Bulletin No.: L03-006  
Release Date: 7/5/06  
Effective Date: Immediately  
Supersedes: N/A  
Completion Date: N/A

# SERVICE BULLETIN

<b>Ride Name: Fireball &amp; Ring of Fire with Fireball train</b>	<b>Affected</b>	<b>Serial</b>	<b>Nos.:</b>
88PA30043		01PT70088	
89PA50049		01PT70089	
90PA50053		01PT70090	
91PA60056		01PT70091	
92PA60059		02PT70092	
95PA60074		02PT70093	
99PA60081		02PT70094	
99PA70082		03PT70095	
99PT70083		03PT70096	
00PT70084		03PT70097	
00PT70085		04PT70098	
00PT70086		04PT70099	
00PT70087		05PT700100

**Abstract Of Issue:**  
**Restraint Bumper Installation**

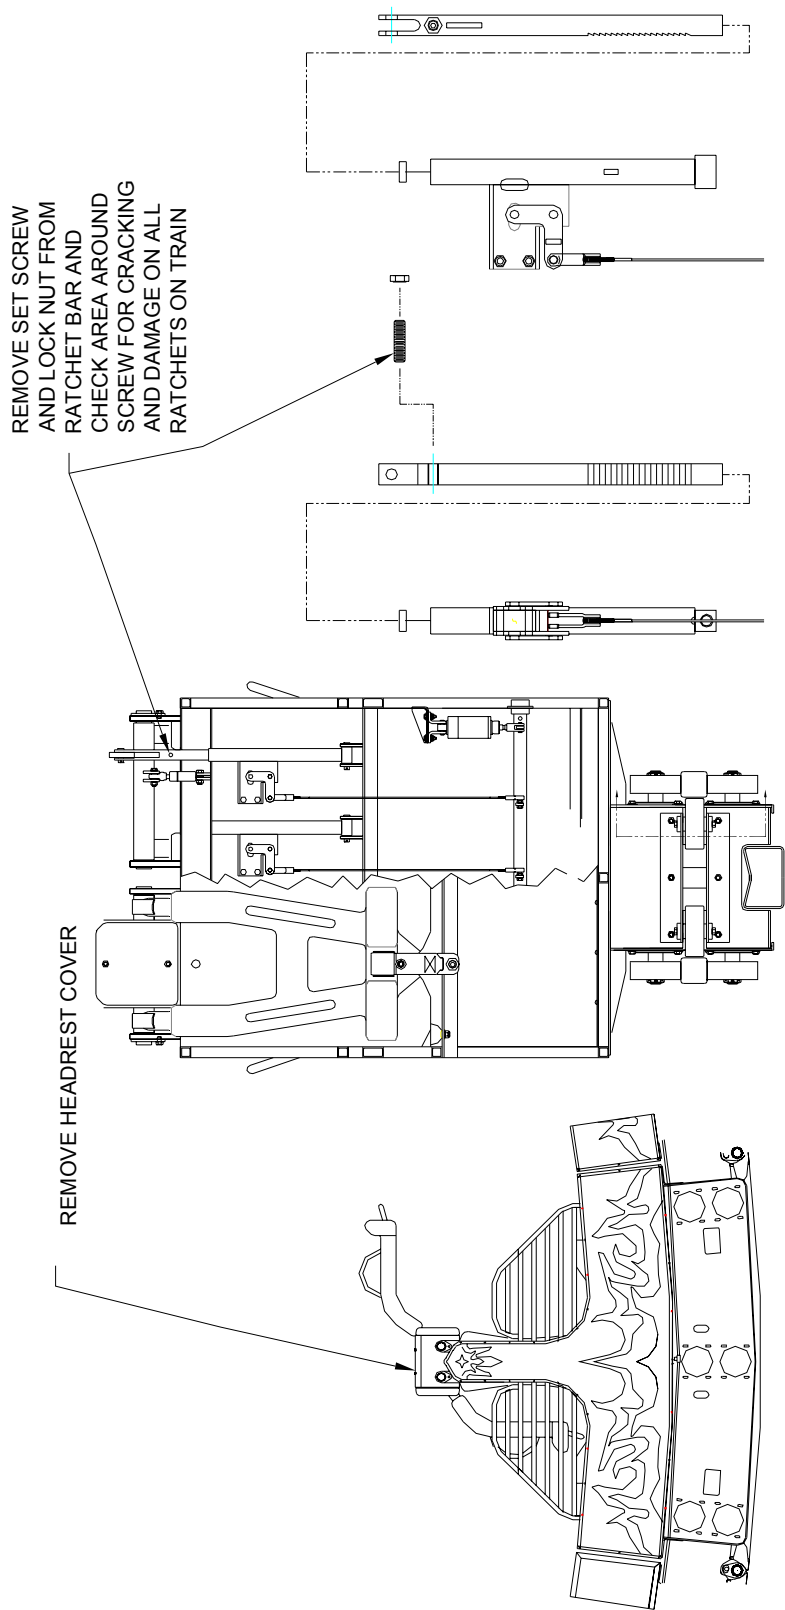
1. Remove all head pad covers.
  2. Remove stop set screw and locknut from upper portion of ratchet assembly.
  3. Add bumper assembly under over the shoulder restraint and weld in place. (see instructions)
  4. Welding must be completed by AWS D1.1 certified welder.
  5. N.D.T inspection of bar at the point where the stop set screw was located is required.
  6. If upon inspection there are signs of bending and or cracking replacing the ratchet bar is necessary.
  7. A copy of the inspection report must be sent to Larson Intl, Inc.
  8. This modification must be completed no later than July 21, 2006. If modifications & N.D.T. are not complete by this date the ride must be taken out of service until testing & modifications are complete
-

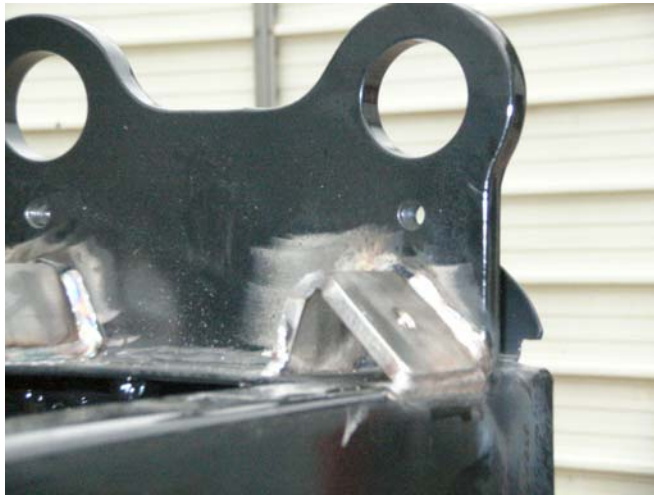
Mount brackets flush with channel.

After weldment and painting are complete screw in rubber bumper as shown.
